STREET ADDRESS		CITY		COUNTY		OFFICE ADDRESS	
ILIFF AND 225		AURORA		ARAPAHOE		ROCKY MOUNTAIN REGION 4643 S. ILLUSTRATION STREET, SUITE 1300, DENVER, COLORADO 80237	
STATE		COLORADO		ARAPAHOE		OFFICE ADDRESS	
50765		39450		50765		39450	
SCALE:		AS NOTED		M&D REF:		BOWAN	
DATE:		04/30/2021		M&D P/C/M:		PROPHET	
DESIGNED BY:		RJP		FILE NAME:		CURRENT.DWG	
DRAWN BY:		RJP		SLS INV. 18-001-111			
CHECKED BY:		RJP					
DRAWING TITLE							
EXISTING CONDITIONS							
SHEET NO.							
2 OF 15

STREET ADDRESS		OFFICE		
ILIFF AND 225		ROCKY MOUNTAIN REGION		
CITY	STATE	COUNTY	CITY	ADDRESS
AURORA	COLORADO	ARAPAHOE	ILIFF AND 225	4643 S. ULLSTER STREET, SUITE 1300, DENVER, COLORADO 80237
STATE STAKE I.D.#		NATIONAL I.D.#		
50765		39450		
REGIONAL DWG. NO.		.		
SCALE:	AS NOTED	M&D REF:	BOWAN	
DATE:	04/30/2021	M&D P/C#	PROPHET	
DESIGNED BY:	RJP	FILE NAME:	CURRENT.DWG	
DRAWN BY:	RJP	CHECKED BY:	RJP	
DRAWING TITLE:				
SITE PLAN				
SHEET NO:				
3 OF 15

GRADING PLAN

FINAL LANDSCAPE PLAN

1  
A2.0 FRONT ELEVATION - EAST  
1/4" = 1'-0"

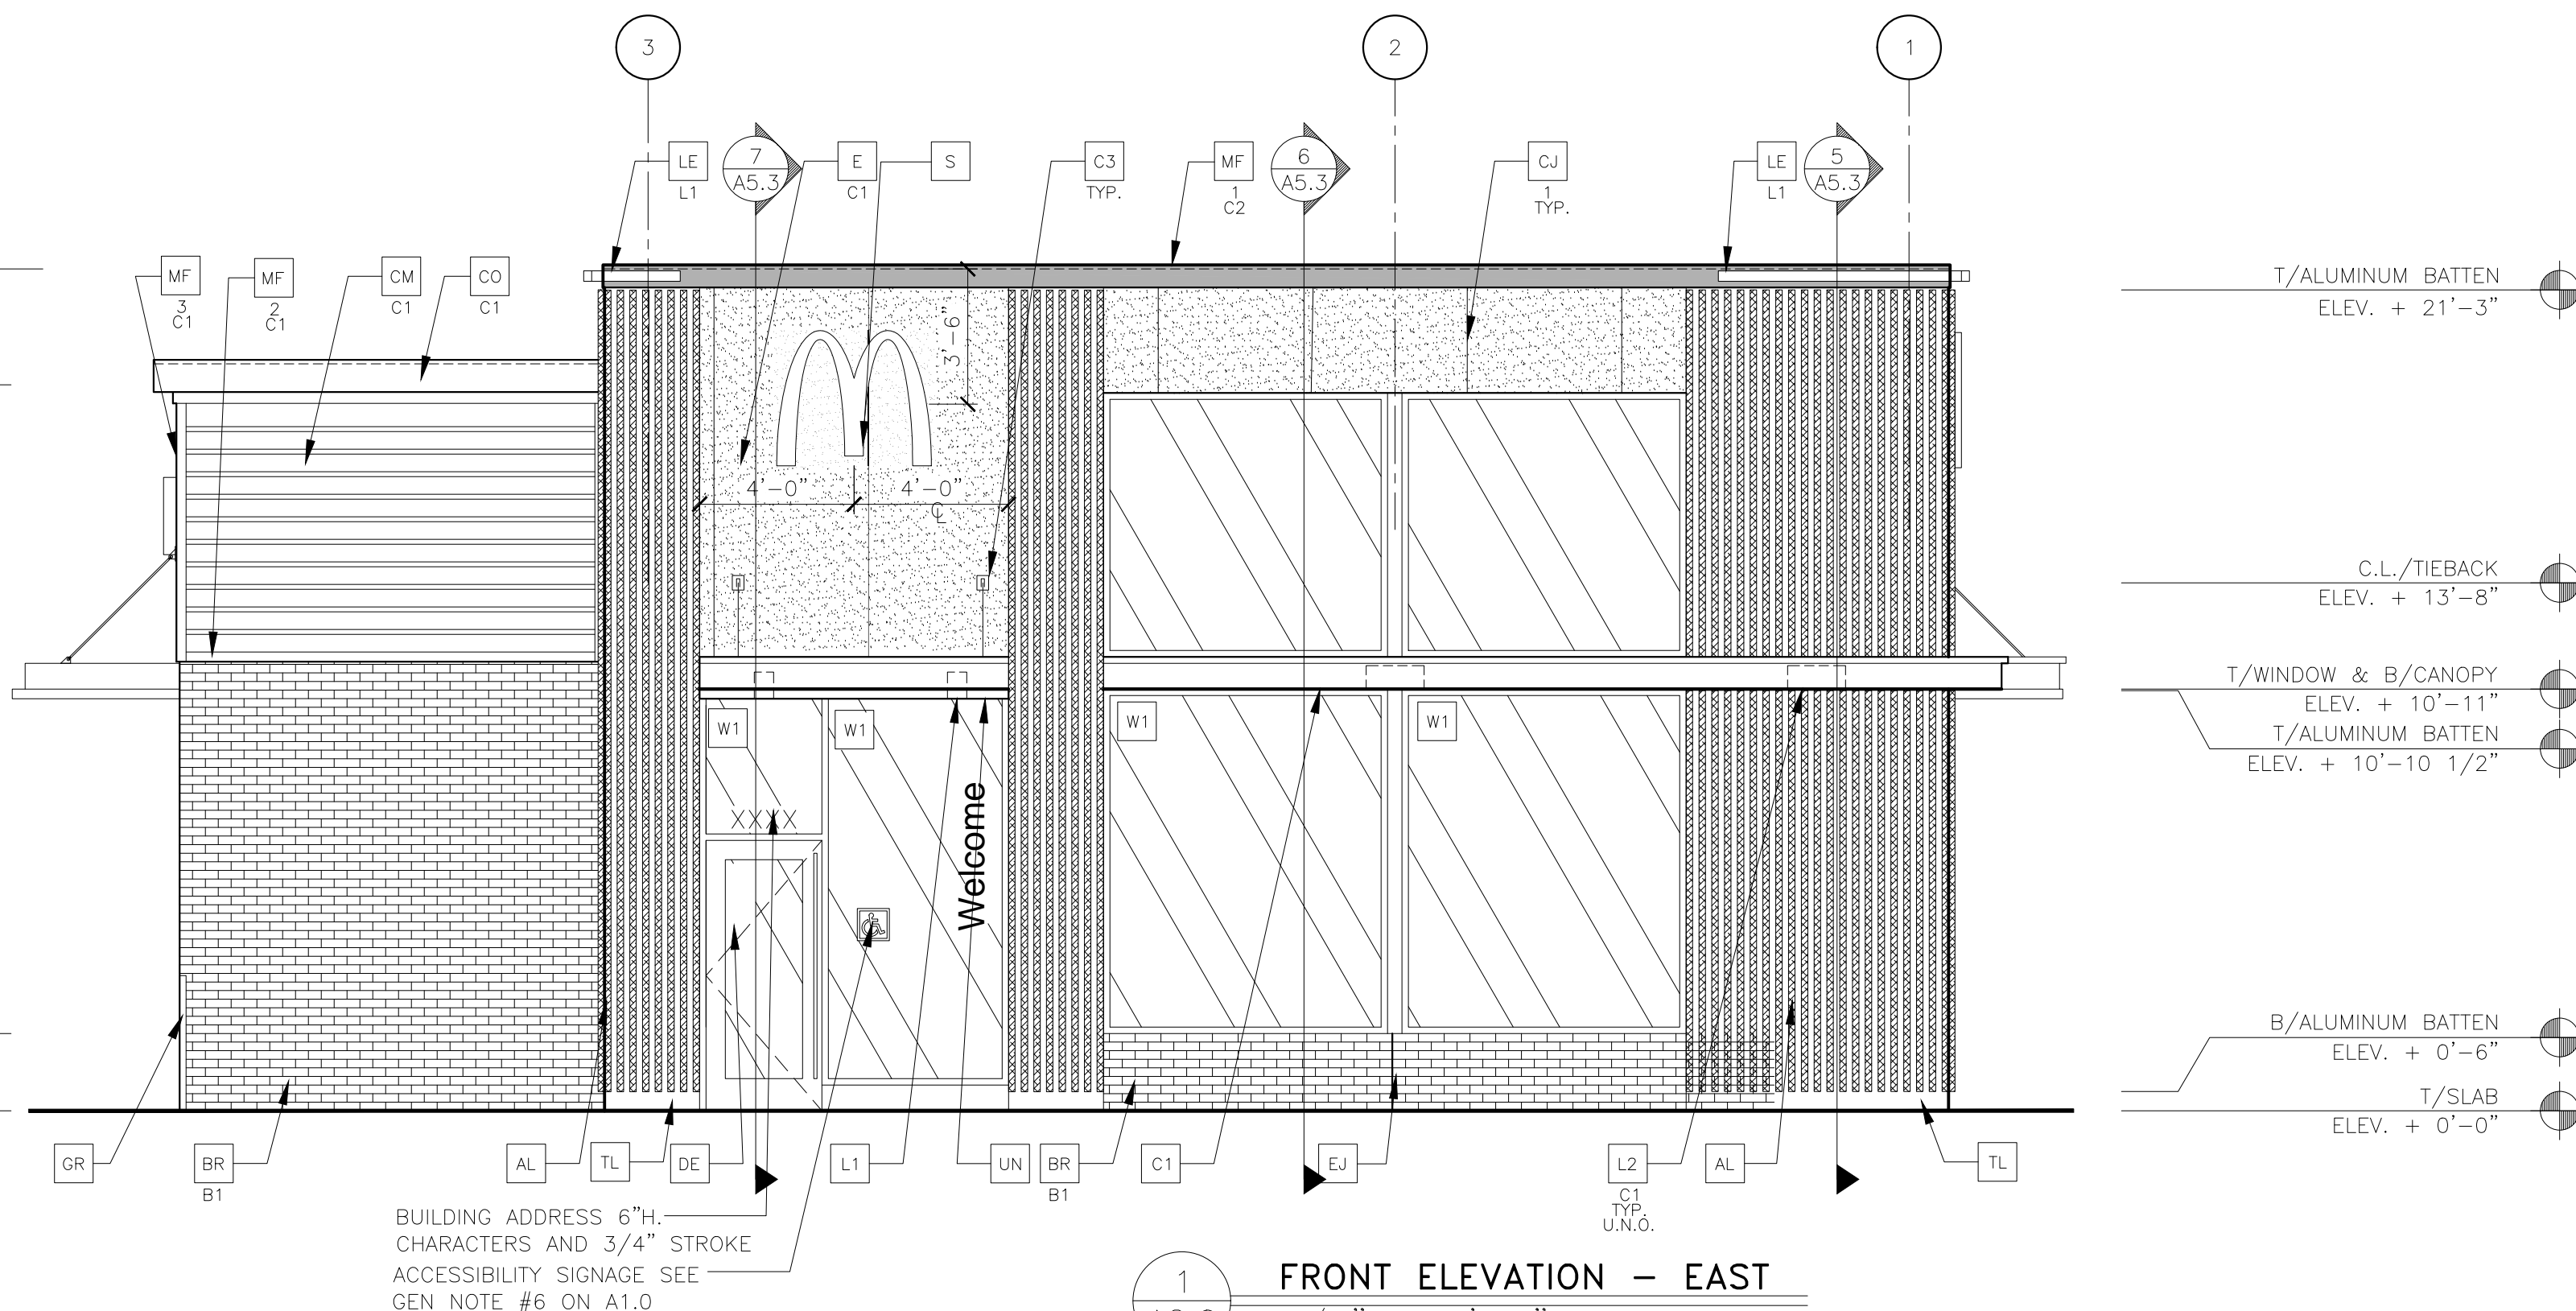
Show the location of the FDC, Knox Boxes & Riser Room:  
- Show symbol and label for the FDC.  
- Show symbol and label for the Knox Box.  
- Show location of Riser Room exterior door.
